MINERALS PROGRAM INSPECTION REPORT**PHONE: (303) 866-3567**

MINE NAME: Sprague Red Lyons	MINE/PROSPECTING ID#: M-1981-057	MINERAL: Sandstone (silica, stone, quartzite)	COUNTY: Boulder
INSPECTION TYPE: Monitoring	INSPECTOR(S): Amy Eschberger	INSP. DATE: July 11, 2017	INSP. TIME: 09:45
OPERATOR: Arkins Park Stone Corporation	OPERATOR REPRESENTATIVE: David Sprague, Chad Theis	TYPE OF OPERATION: 112c - Construction Regular Operation

REQUEST FOR TECHNICAL REVISION (TR) COVER SHEET

M1981-057 / Sprague Red Lyons / Arkins Park Stone Corporation

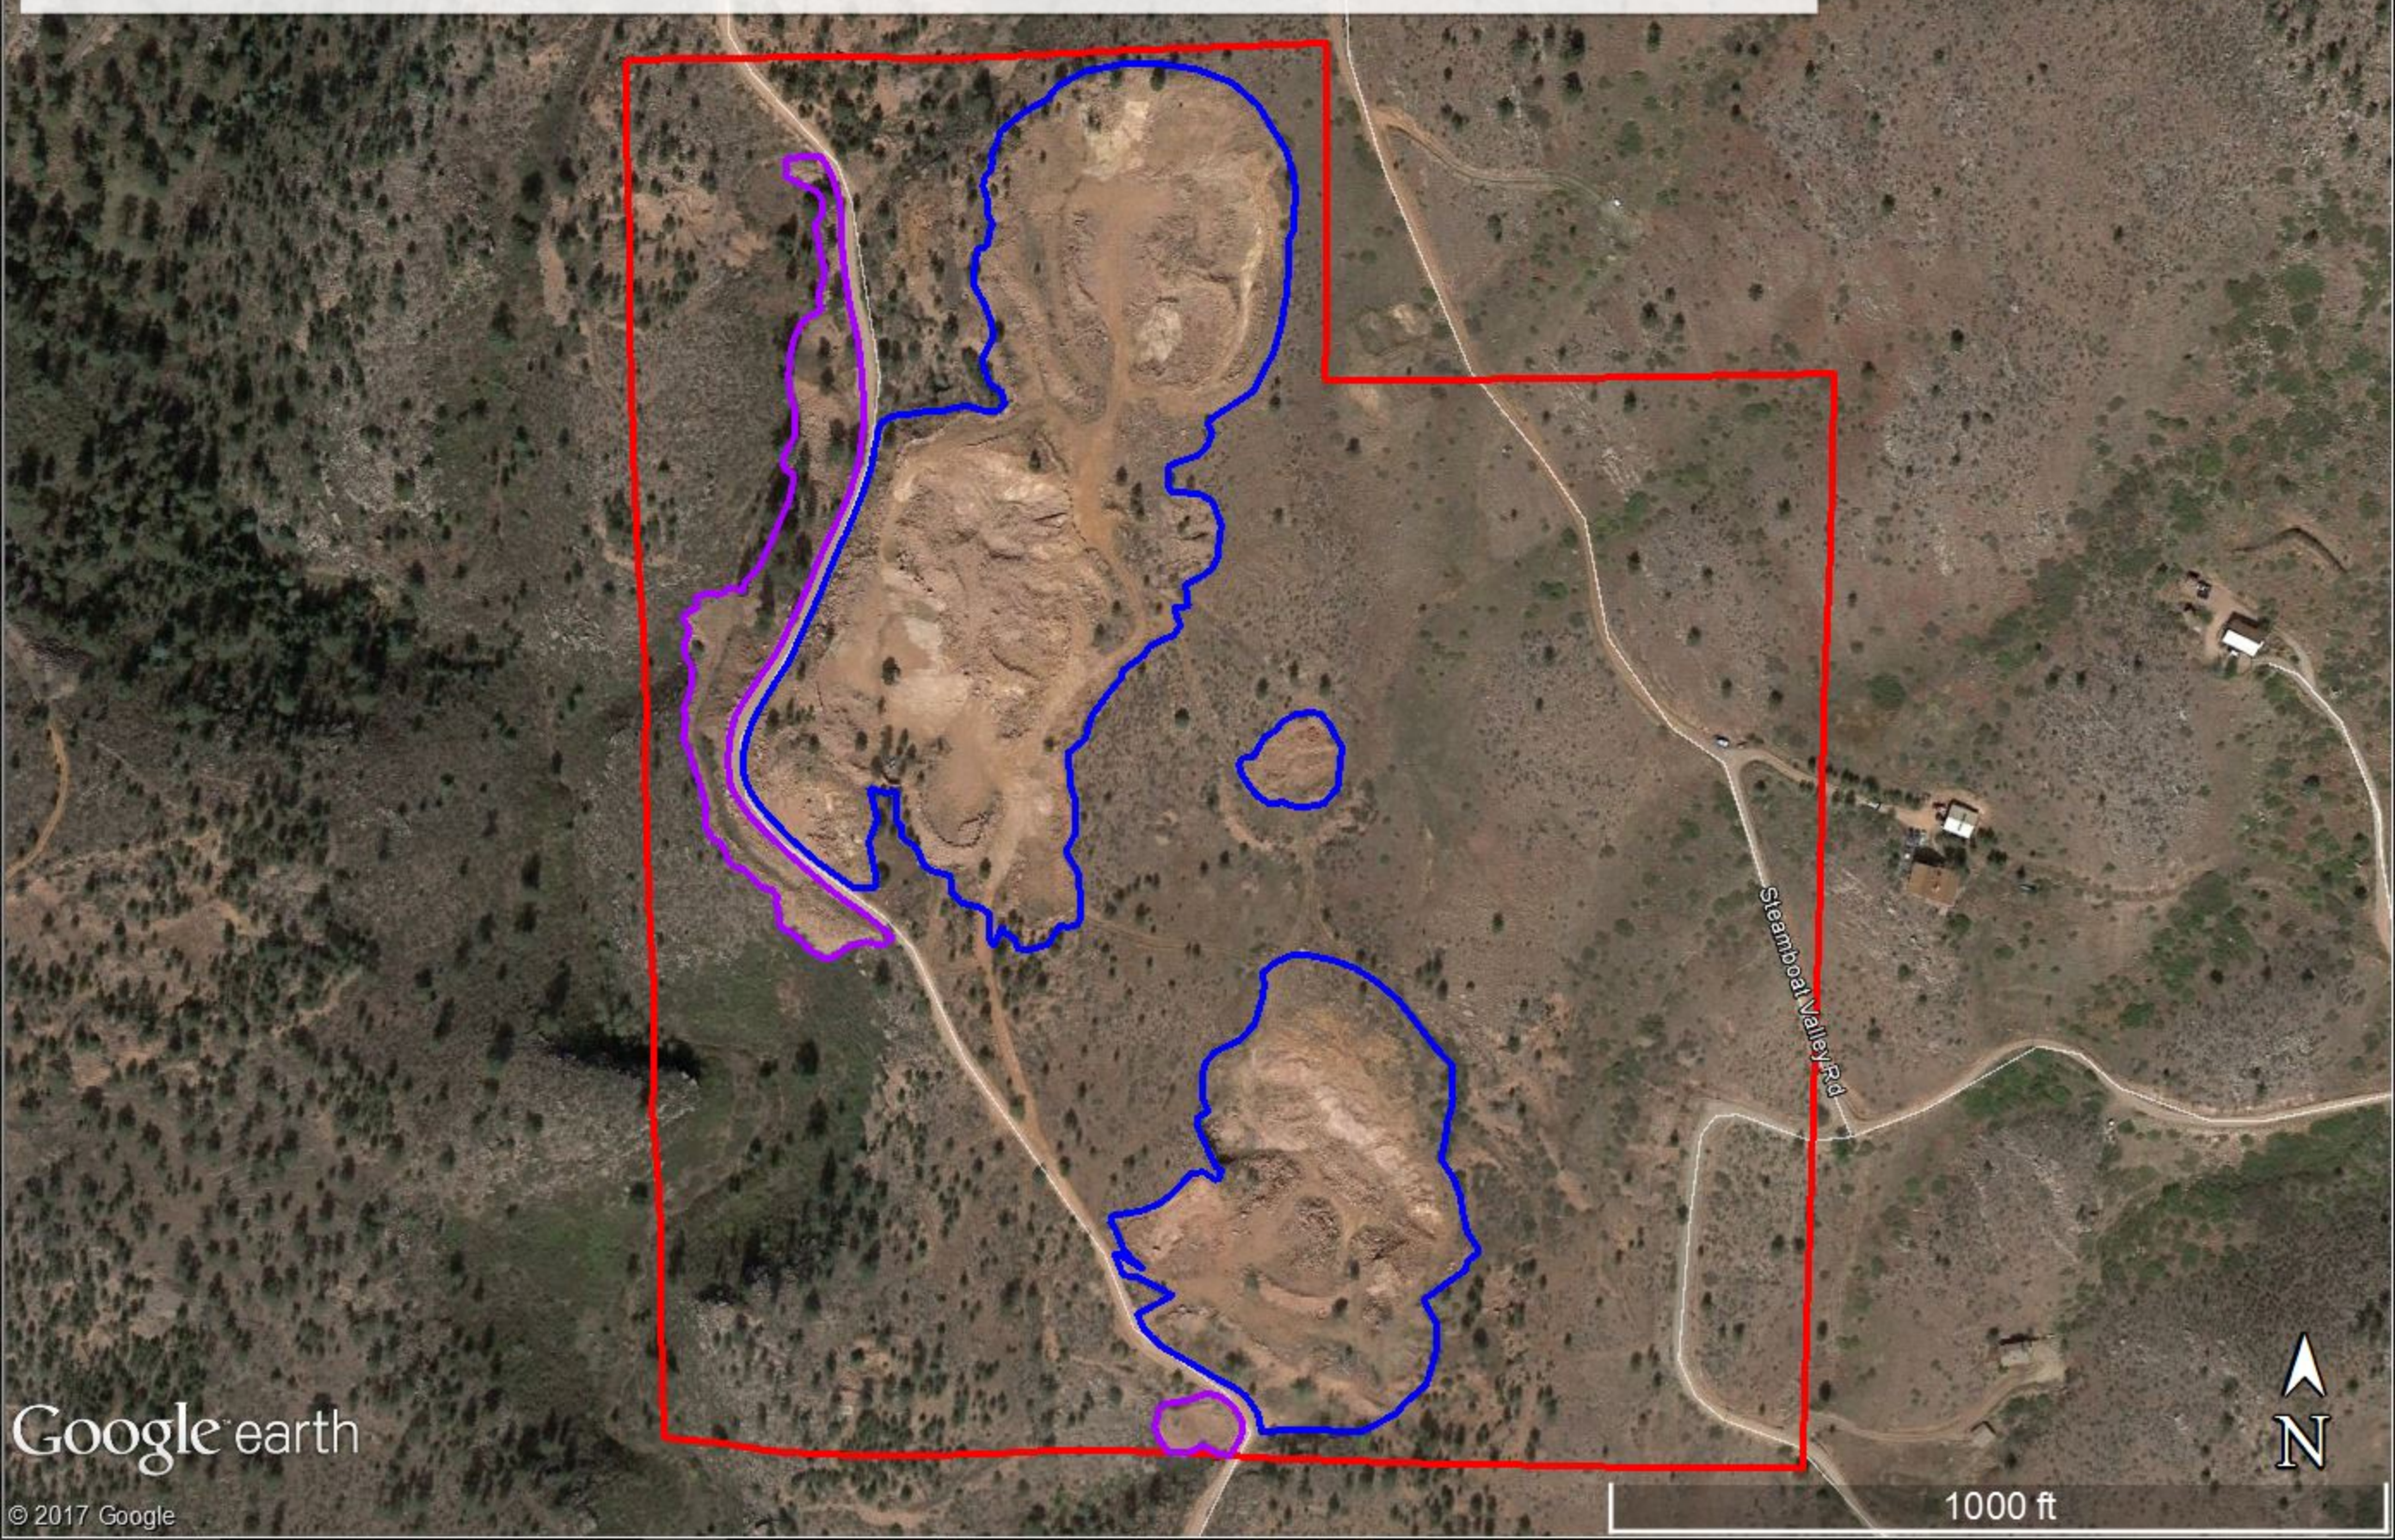
After conducting the inspection, the Division recalculated the required financial warranty for completing reclamation of the site in accordance with the approved reclamation plan. The Division estimates a total of approximately 15 acres have been disturbed by the operation that require reclamation (**see enclosed Google Earth image of site**). The revised bond estimate includes costs for backfilling quarry areas with 6 inches of

overburden/waste rock material, backfilling near vertical portions of highwalls present in Quarries 1 and 3 to 3H:1V, replacing growth medium across quarry areas at a depth of 6 inches, and revegetating the land with the approved grass seed mixture and tree plantings. Costs for reclaiming the 0.25 acre disturbed area located between Quarries 2 and 3 are included with reclamation costs estimated for the quarry areas. The Division did not include costs for reclaiming the large rubble piles present on the west side of the road, because, as mentioned above, it appears to have been determined that any attempts to reclaim the piles would cause more damage than leaving the piles as-is.

Red outline = 59.7 acres = Approved permit area

Blue outline = 15 acres = Total disturbed area to be reclaimed

Purple outline = 2.12 acres = Disturbed area for rubble piles (to remain as-is)

The Division has determined the required financial warranty for the site to be in the amount of \$47,050.00 (see enclosed bond estimate), which is \$20,550.00 more than the currently held financial warranty. Therefore, the Division is citing a problem in this report for failure to maintain the proper financial warranty amount to complete reclamation of the affected lands pursuant to C.R.S. 34-32.5-117(4)(b). A notice of surety increase will be mailed to the operator under separate cover. The operator will have 60 days from the date of the notice to post the additional required financial warranty. To reduce the required financial warranty for the site, the operator may complete reclamation of disturbed areas and provide photographic evidence this has been done. If sufficient evidence is submitted within 60 days of the notice of surety increase, the Division could adjust the required financial warranty accordingly.
